Ageas Bowl, Hampshire

Flood and Drainage Addendum

A Flood Risk Assessment (FRA) for the proposed development of the site at the Ageas Bowl (planning reference number F/22/93194) was provided by Andy Clay Consulting (ACC) in August 2022.

An updated FRA was provided in July 2023. The LPA are Eastleigh Borough Council (EBC) and the LLFA are Hampshire County Council (HCC). LPA and LLFA comments on the July 2023 FRA were received in November 2023.

Figure 1 – Sections of Pipe Identified by the LLFA

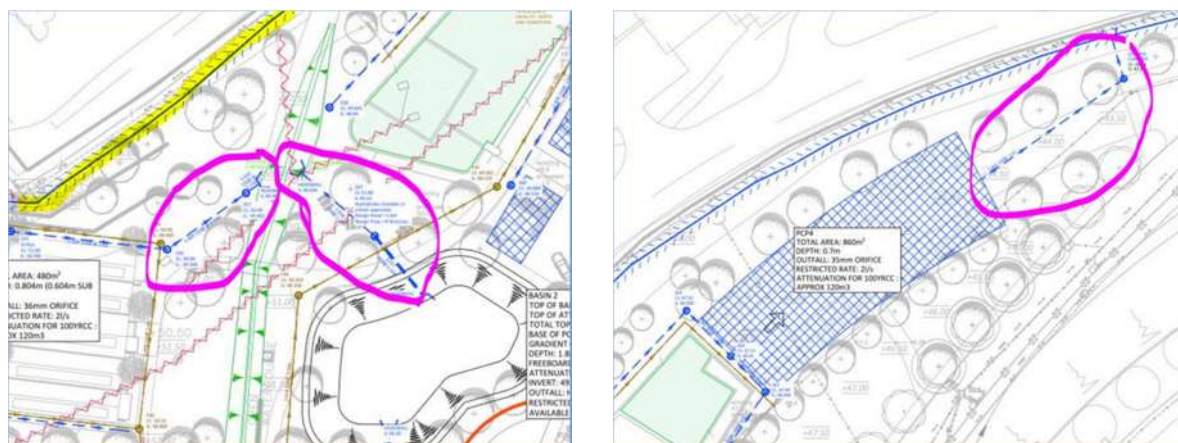
There are three sections of pipe within the surface water drainage strategy that the LLFA have identified and asked if they could instead be open drainage channels, as shown in **Figure 1**.

We have taken a look at the viability of completing this, and unfortunately the depth to the invert levels of the pipes is the main constraint to providing open drainage channels.

Given the requirement to provide 1:3 bank side slopes and with the depth of these pipes, this would require a wide grading to be included either side of any potential open flow channel. This would result in the loss of an area of accessible public open space where benches are currently proposed.

We do not therefore feel that this is viable and the best overall solution for the proposed development.

Figure 2 – Section of Pipe Identified by the LLFA

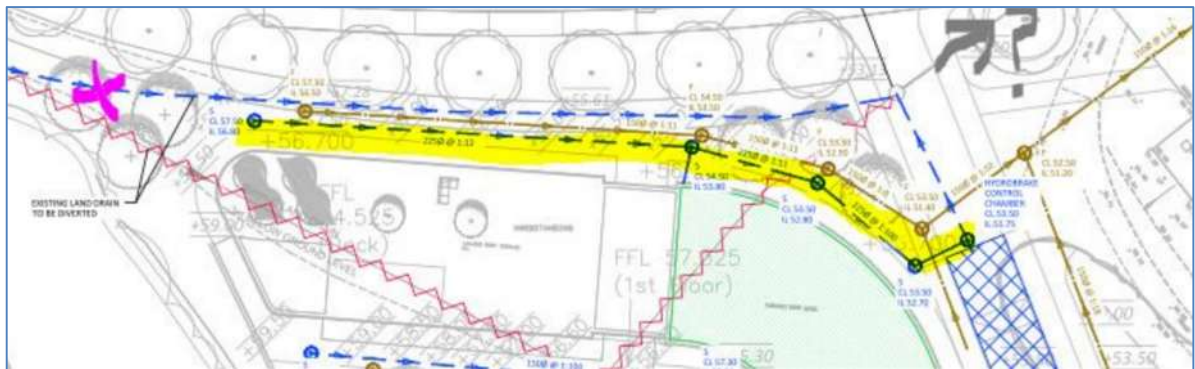
The LLFA make reference to a drainage pipe which they highlighted in yellow on **Figure 2**, and advise that this is a new surface water drain but that it does not pass through any form of filtration.

The LLFA also advise that it was unclear where the surface water pipe marked with a pink X is from. The annotation on the drainage plan clarifies this (as shown on **Figure 2**). It is an existing land drain that is to be diverted, but with the lower section continuing to drain as it does at present (i.e. into the lakes).

Drainage from the residential home discharges to a 600mm diameter pipe and then drains north-east towards the lakes, as described above. The lakes would therefore provide additional biodiversity benefit and natural filtration. We would also suggest that rain gardens could be incorporated into the building design, at detailed design stage, to provide additional biodiversity benefit and natural filtration.
